2020 Paving Project(s) – Phase II

Heritage Elementary School

ADDENDUM NO. 2

January 28, 2020

1 PARTIAL SITE PLAN - ELECTRICAL

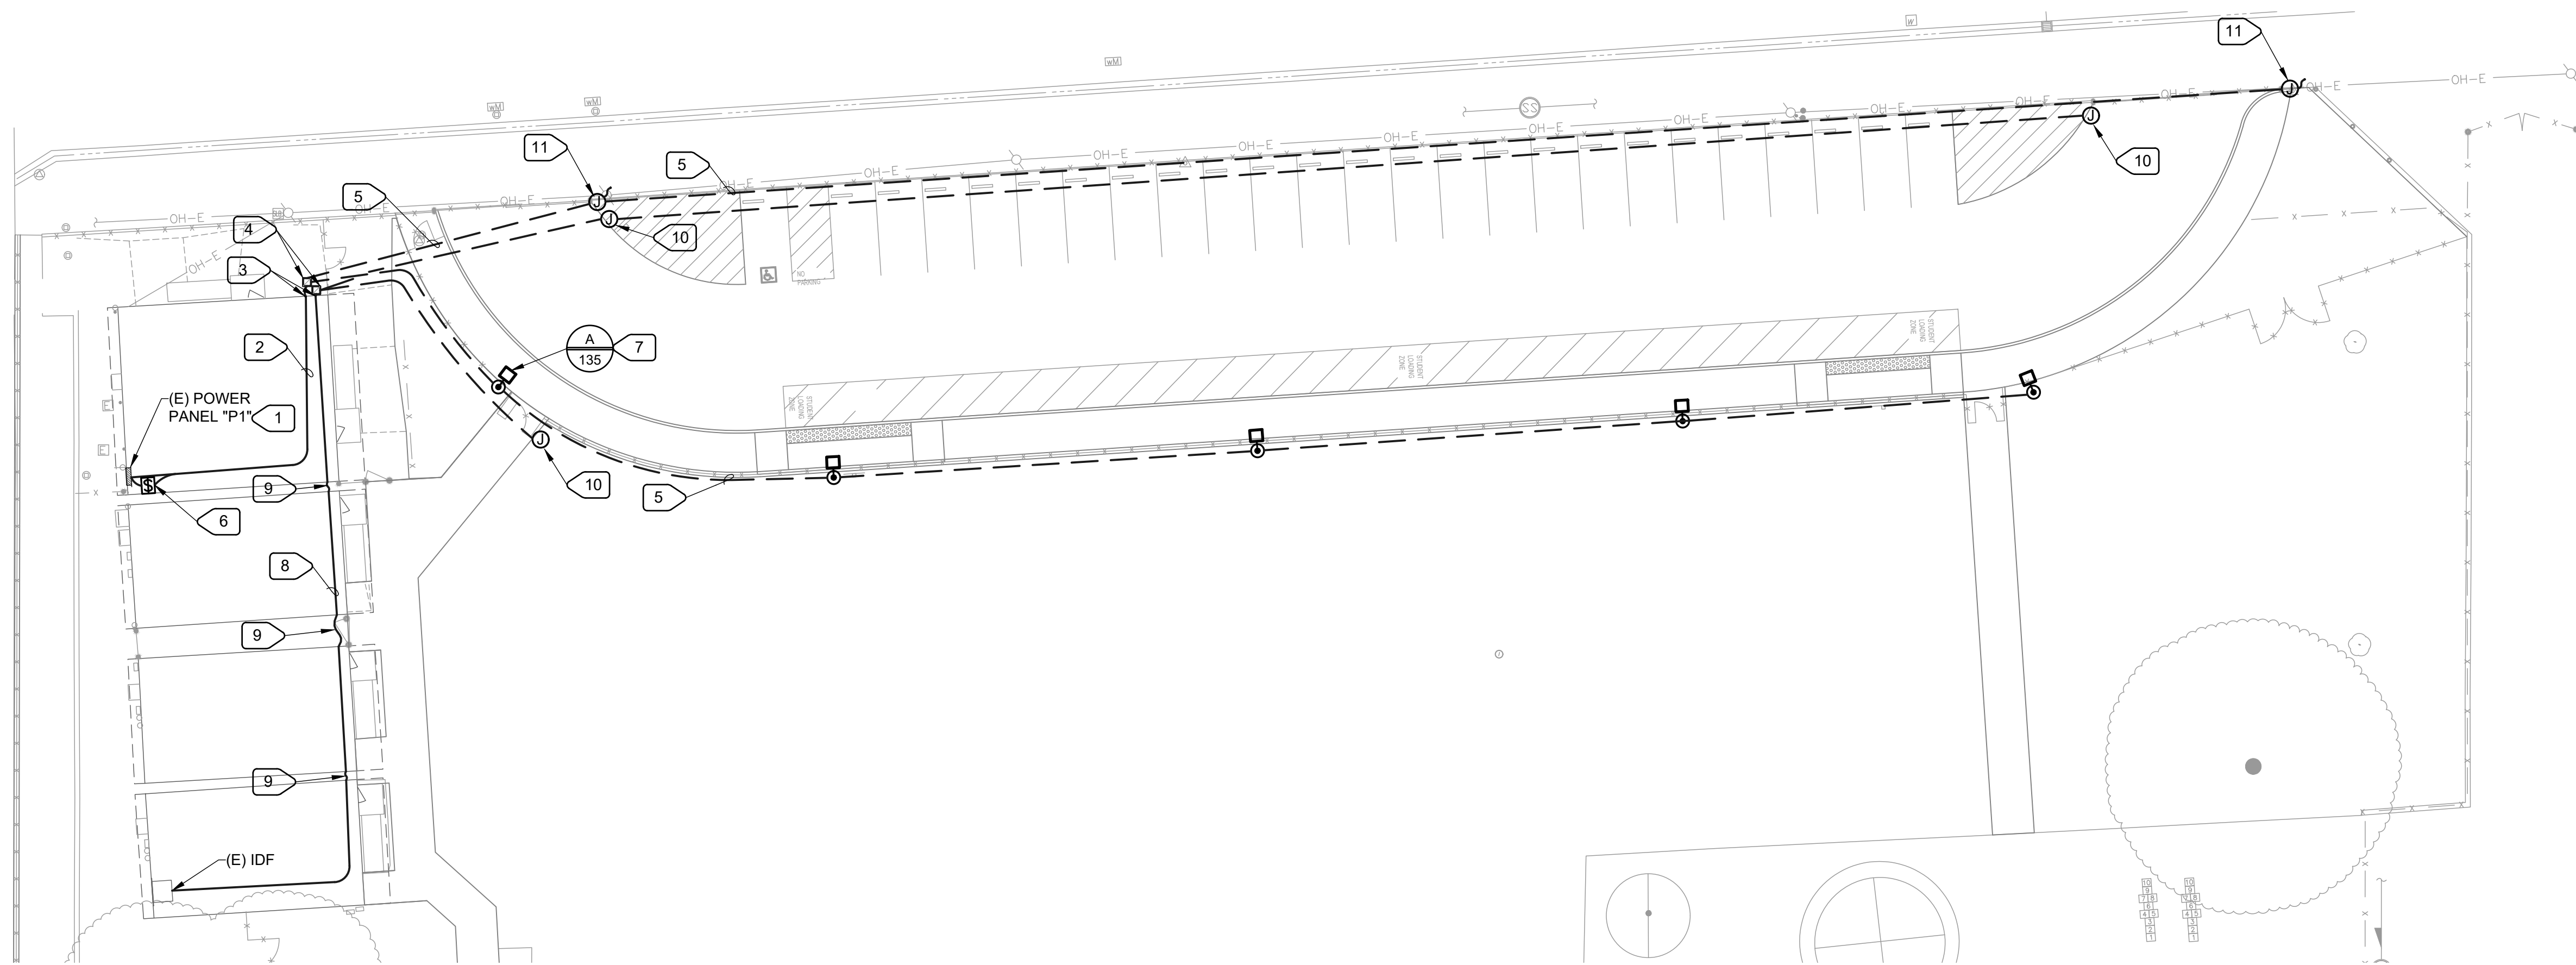
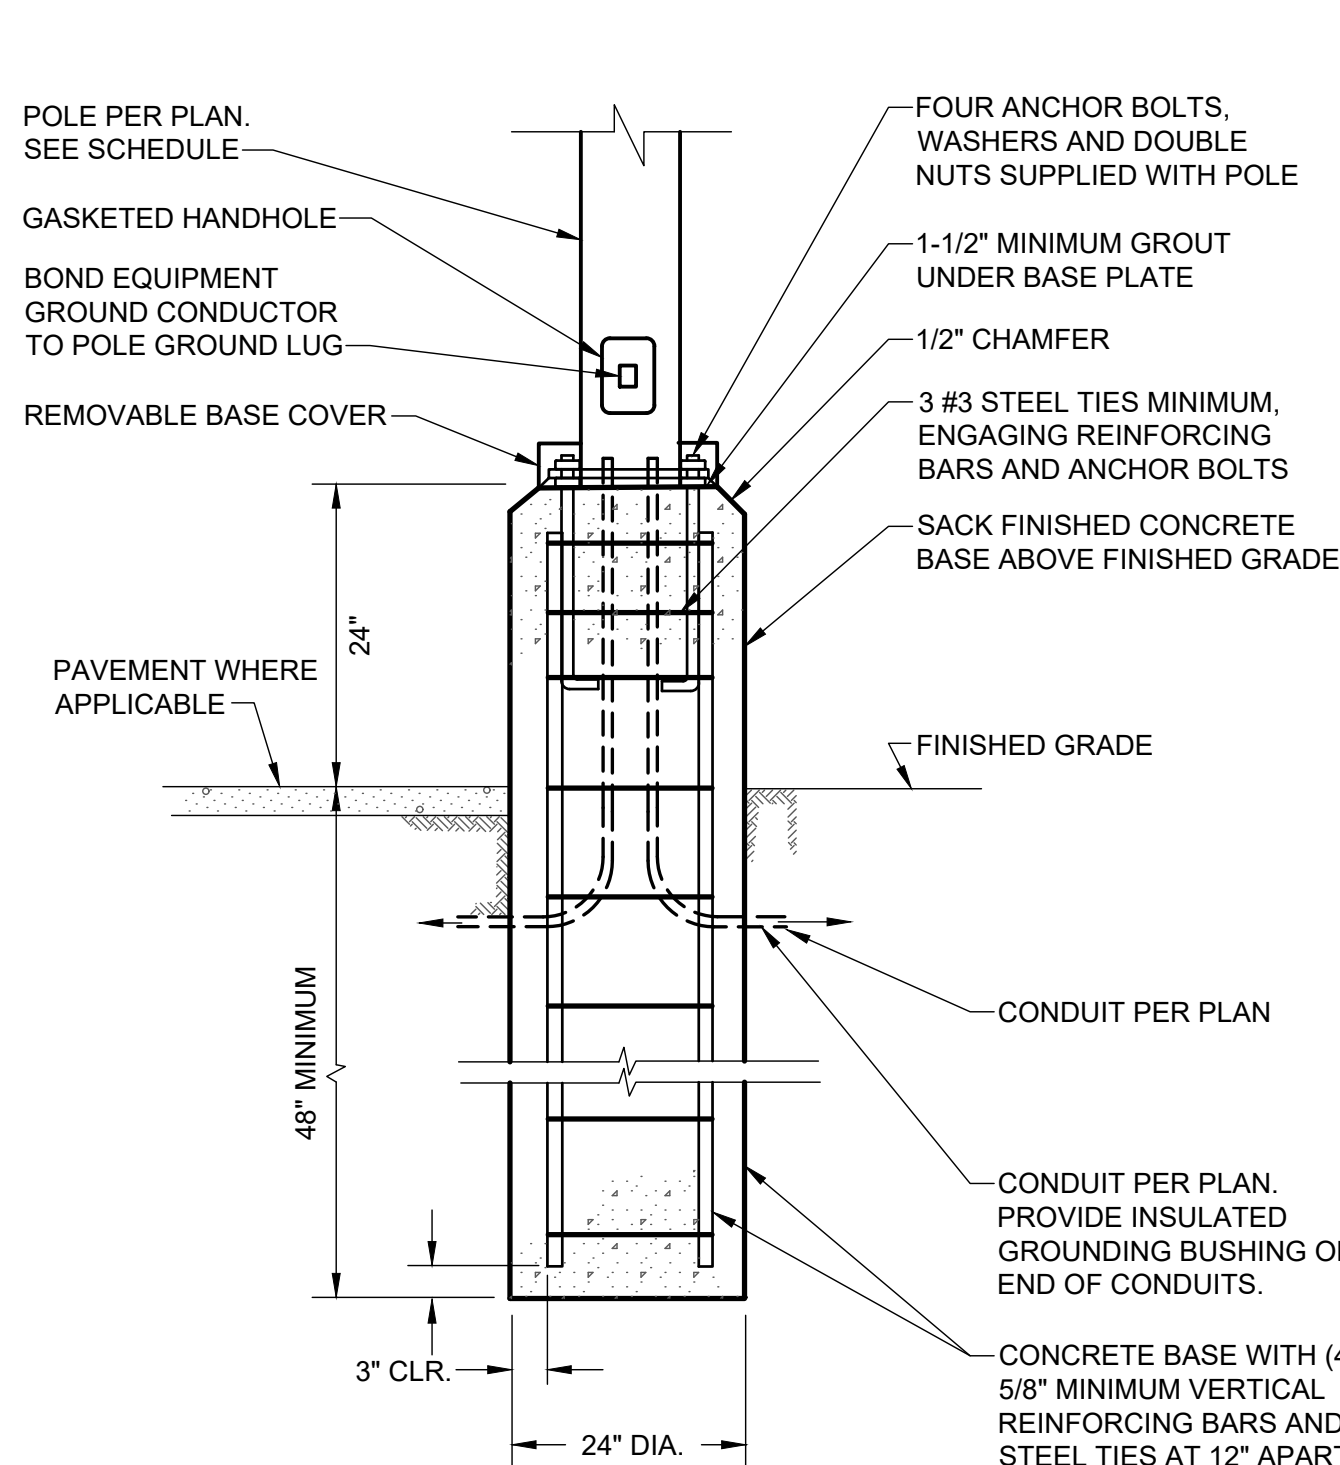
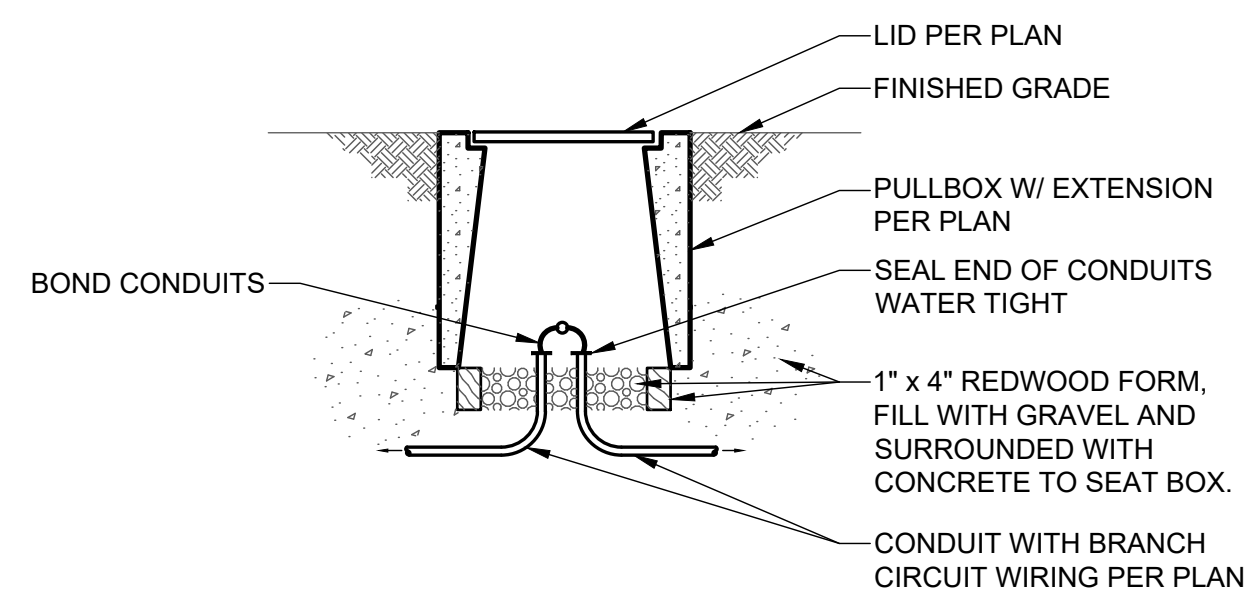
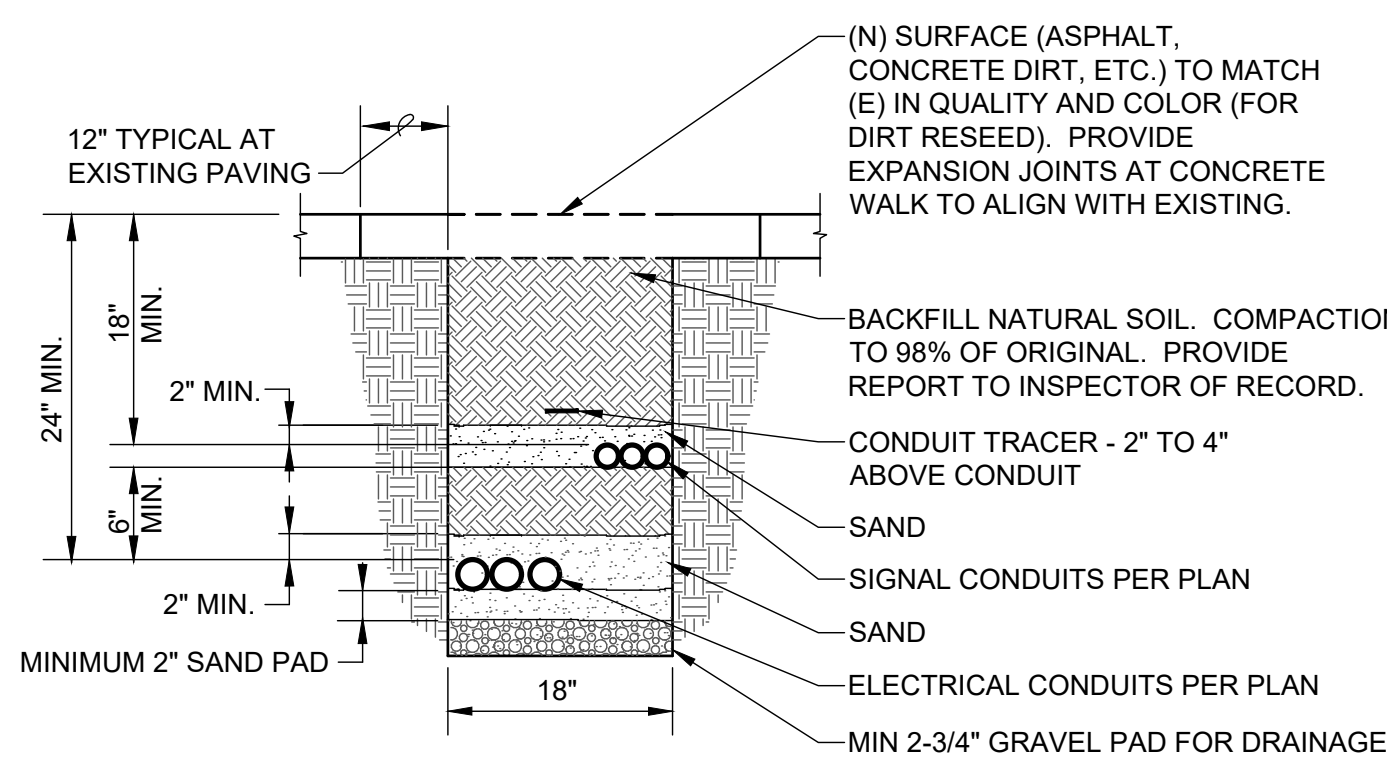
Response: Native material is acceptable.
- 1.21 **Question:** Can we backfill the conduit with native material?
Response: Refer to Drawing Sheet E100 Partial Site Plan – Electrical, dated 01/24/20 for clarification.

- 1.22 **Question:** How deep does the conduit need to be from finish grade?
Response: Refer to Drawing Sheet E100 Partial Site Plan – Electrical, dated 01/24/20 for clarification.

- 1.24 **Question:** Note 16 on sheet C3.1 calls for 2 conduits but is pointing to two different lines. So are there 2 conduits or 4 conduits running to the pull boxes?

Response: Refer to Drawing Sheet E100 Partial Site Plan – Electrical, dated 01/24/20 for clarification.
- 1.25 **Question:** Will we need to phase the demolition and grading of the work to be done closer to the school along the path of travel after students are not in school anymore? Will we need to fence these off if kids are still in school?
